UNITED STATES
NUCLEAR REGULATORY COMMISSION
WASHINGTON, D. C. 20555

The Commission has issued the enclosed Amendments Nos. 93, 93, and 90 for Licenses Nos. DPR-38, DPR-47 and DPR-55 for the Oconee Nuclear Station, Units Nos. 1, 2 and 3. These amendments consist of changes to the Station's common Technical Specifications (TSs) in response to your request dated August 25, 1980, as supplemented December 22, 1980 and January 22, 1981.

SAFETY EVALUATION BY THE OFFICE OF NUCLEAR REACTOR REGULATION

OCONEE NUCLEAR STATION, UNITS NOS. 1, 2 AND 3

Figure 2.1-2C

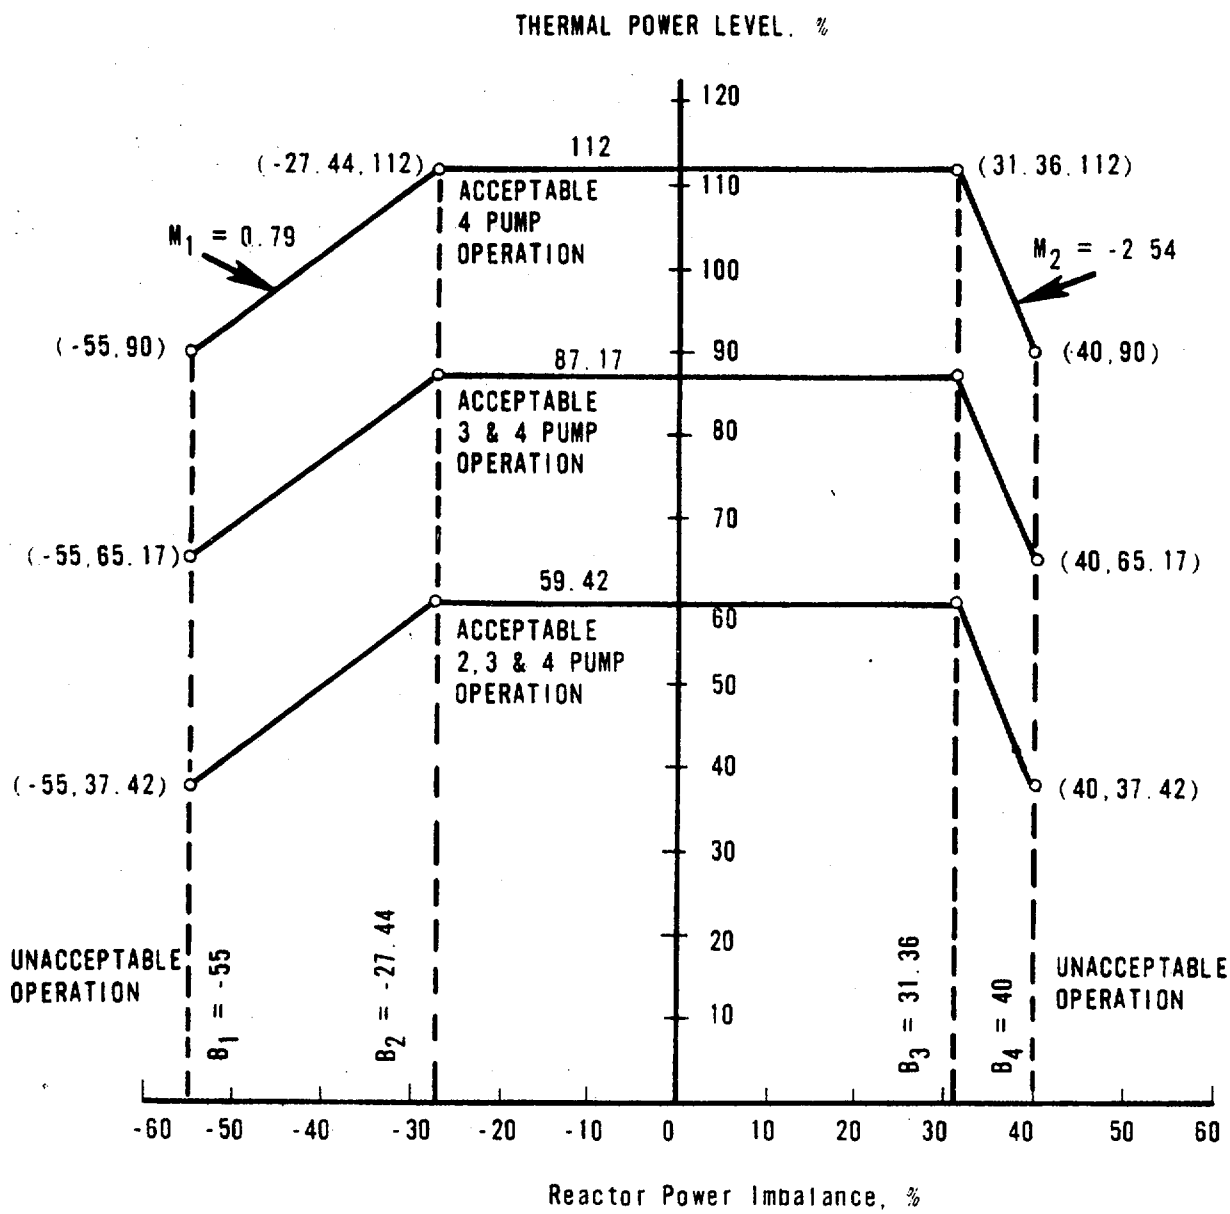
The specified flow rates for Curves 1, 2 and 3 of Figure 2.1-2C correspond to the expected minimum flow rates with four pumps, three pumps and one pump in each loop, respectively.

Figure 2.1-3C

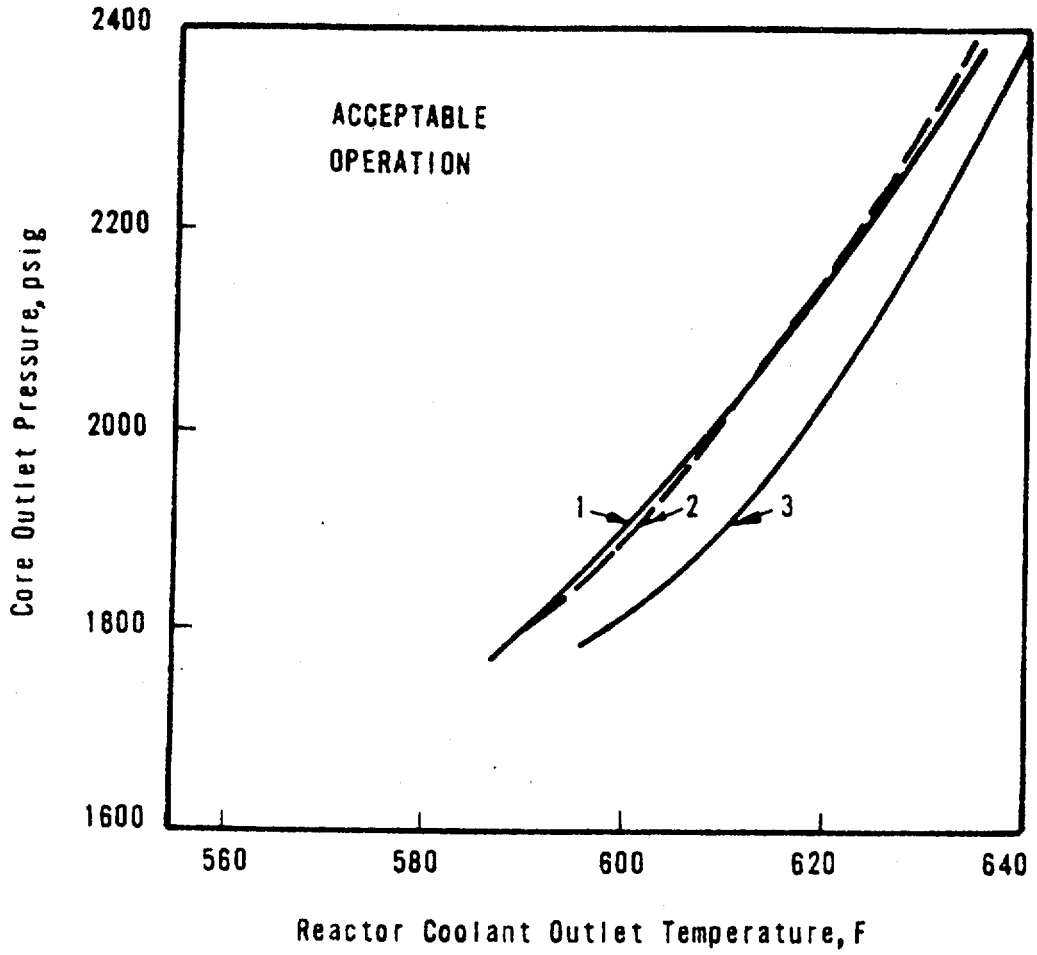
For each curve of Figure 2.1-3C a pressure-temperature point above and to the left of the curve would result in a DNBR greater than 1.30 or a local quality at the point of minimum DNBR less than 22 percent for that particular reactor coolant pump situation. The curve of Figure 2.1-1C is the most restrictive of all possible reactor coolant pump-maximum thermal power combinations shown in Figure 2.1-3C.

The proposed modifications to the Core Protection Safety Limits of Specification 2.1 (Figure 2.1-3C, Page 2.1-12 of Ref. 1) have been reviewed for the Oconee 3 Cycle 6 operation, and we find the revised TSs acceptable. The TS changes related to cycle length and shutdown margin have been reviewed in Sections 2.7 and 2.8 of this Safety Evaluation.

ROD POSITION LIMITS
FOR FOUR-PUMP OPERATION
AFTER 200 (± 10) EFPD
UNIT 3
OCONEE NUCLEAR STATION
Figure 3.5.2-1C3

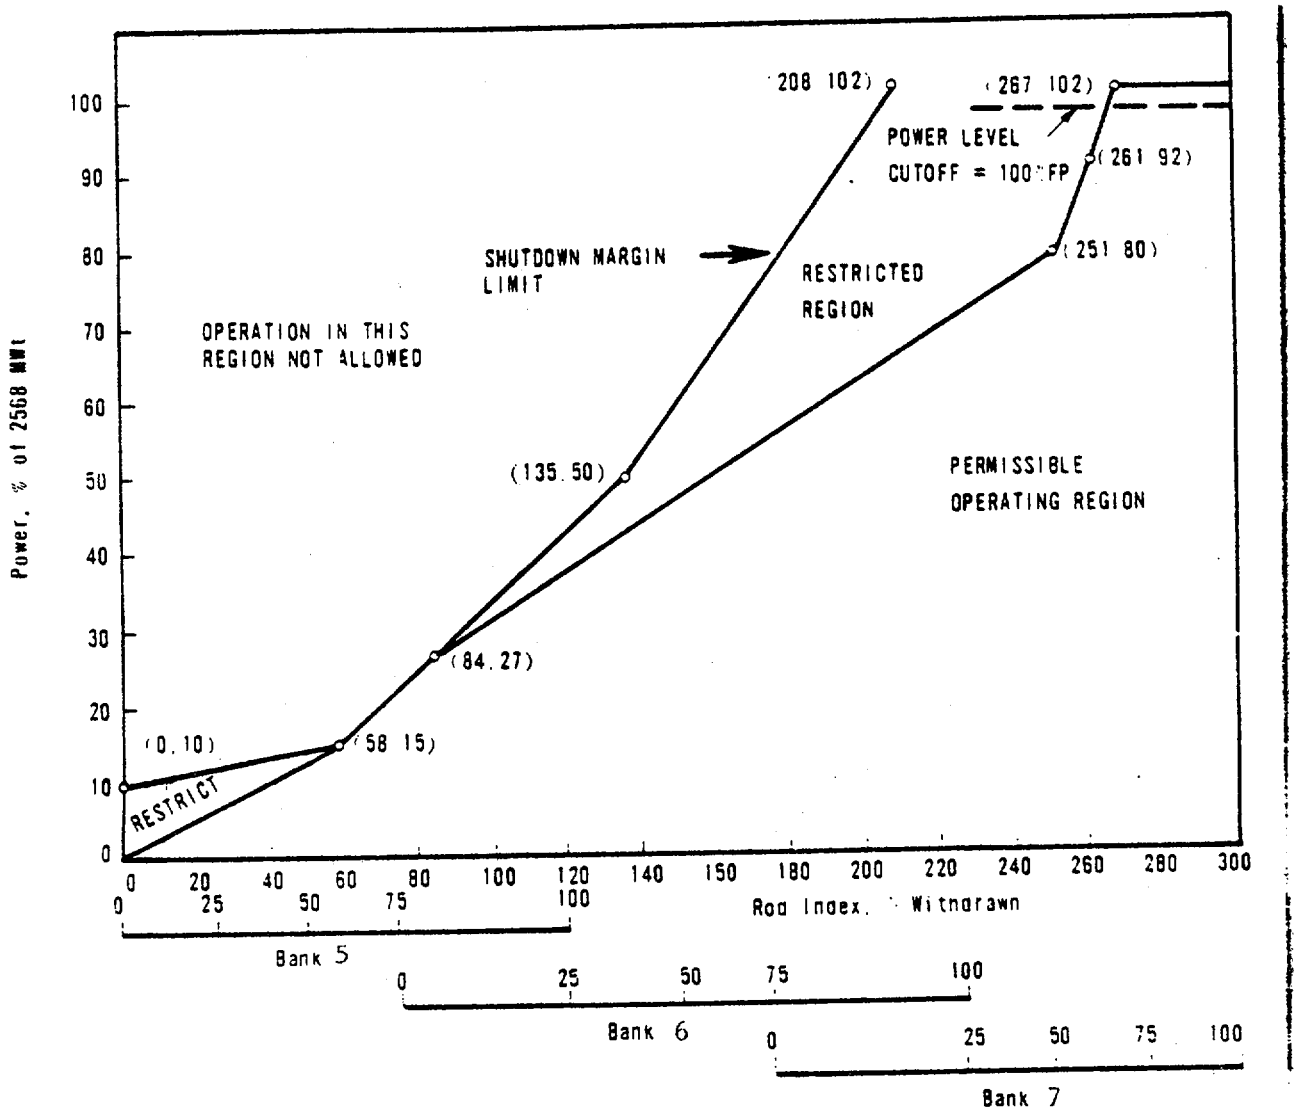
A further TS (3.5.2.9) specifies that the curves shown in the various Specifications shall be valid only to the end of the nominal cycle length (in spite of the open ended nature, e.g., Figure 3.5.2-1C3 which is designated for use after 200 $\pm$ 10 EFPD).

However, use of these curves would be permitted after the end of the nominal cycle if analyses are performed which confirm their suitability. Such use would not, therefore, involve a TS change. If analyses failed to confirm the suitability of the curves, a TS change would have to be obtained to continue operation beyond the nominal cycle length. We find this approach to be acceptable.

3.5.2.9 The operational limit curves of Technical Specifications 3.5.2.5.c. and 3.5.2.7 are valid for a nominal design cycle length, as defined in the Safety Evaluation Report for the appropriate unit and cycle. Operation beyond the nominal design cycle length is permitted provided that an evaluation is performed to verify that the operational limit curves are valid for extended operation. If the operational limit curves are <u>not</u> valid for the extended period of operation, appropriate limits will be established and the Technical Specification curves will be modified as required.
